KAPREALIAN ENGINEERING  
INCORPORATED

KEI-P91-1004.P5A  
February 23, 1995

RE: Addendum to Work Plan/Proposal  
Unocal Service Station #5043  
449 Hegenberger Road  
Oakland, California

**FIGURE  
1**

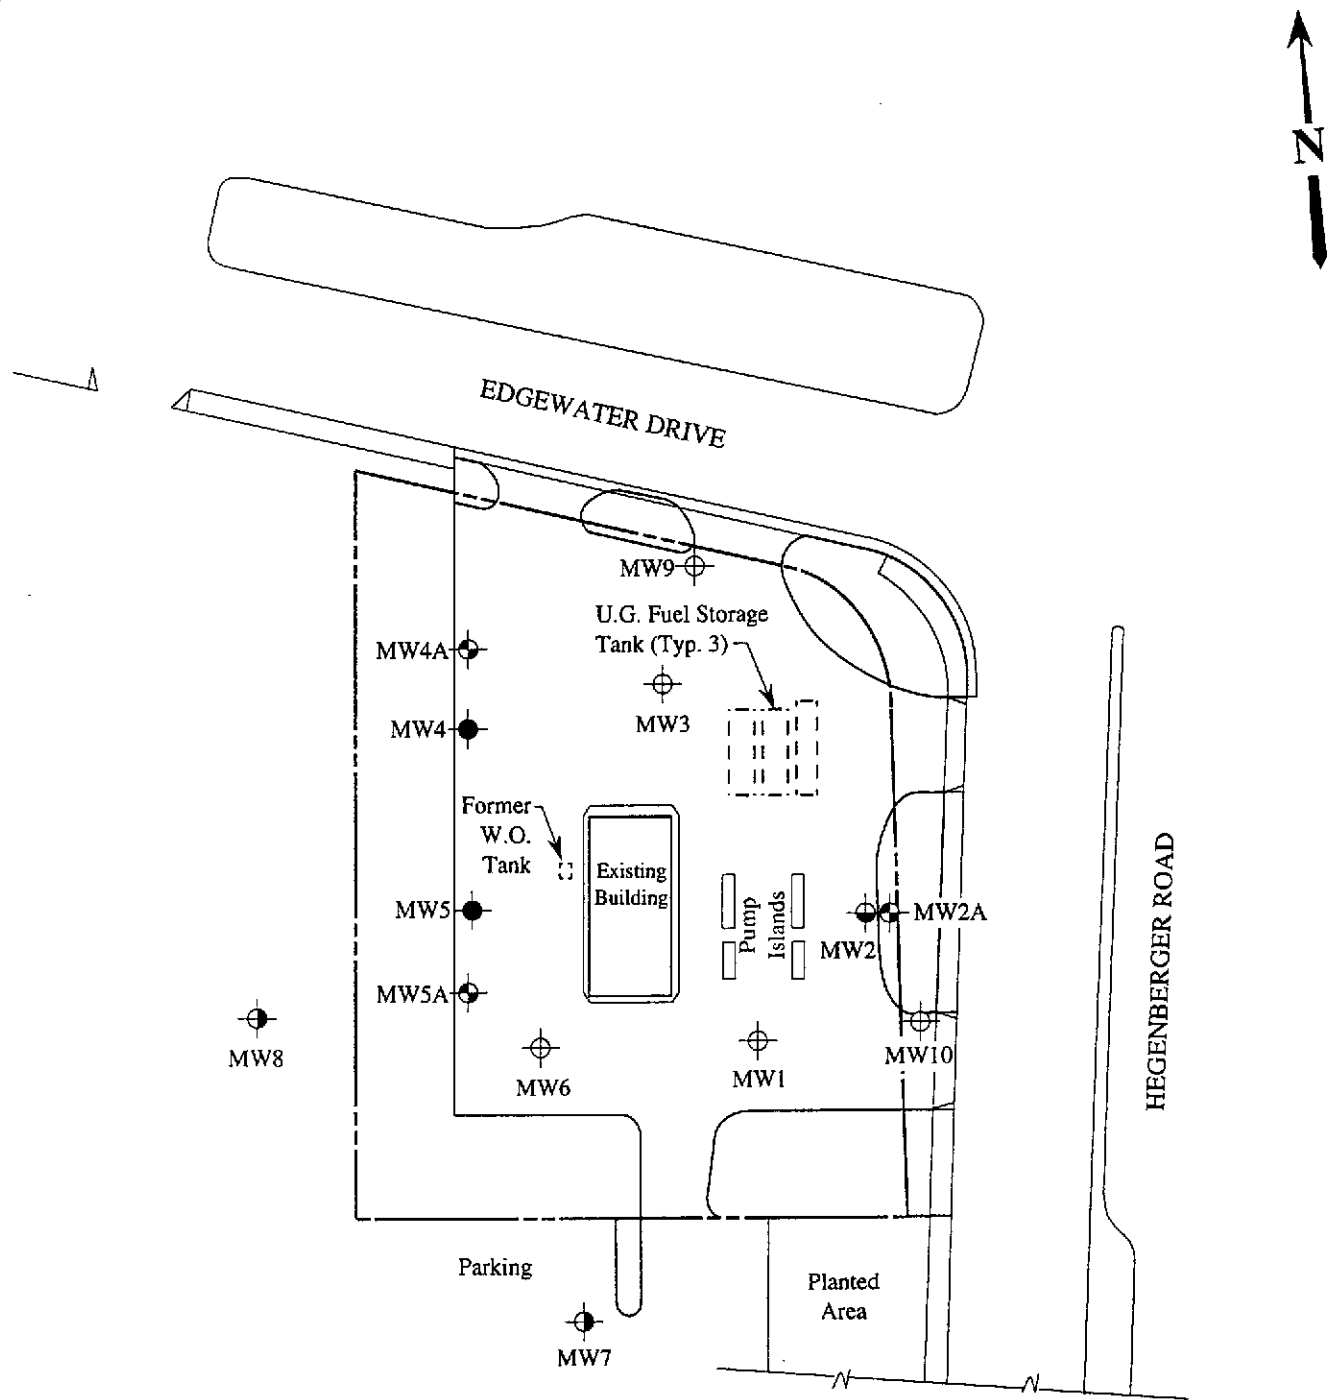
On-site construction activities now make the destruction and replacement of well MW2 necessary. This work will be carried out in accordance with the above referenced work plan (KEI-P91-1004.P5). It will be necessary to reinstall MW2A on a separate date after construction activities are completed. The locations of the existing, destroyed, and proposed on-site wells are shown on the attached Figure 1. The results of the well installation will be included in the report for the installation of proposed wells MW7 through MW10.
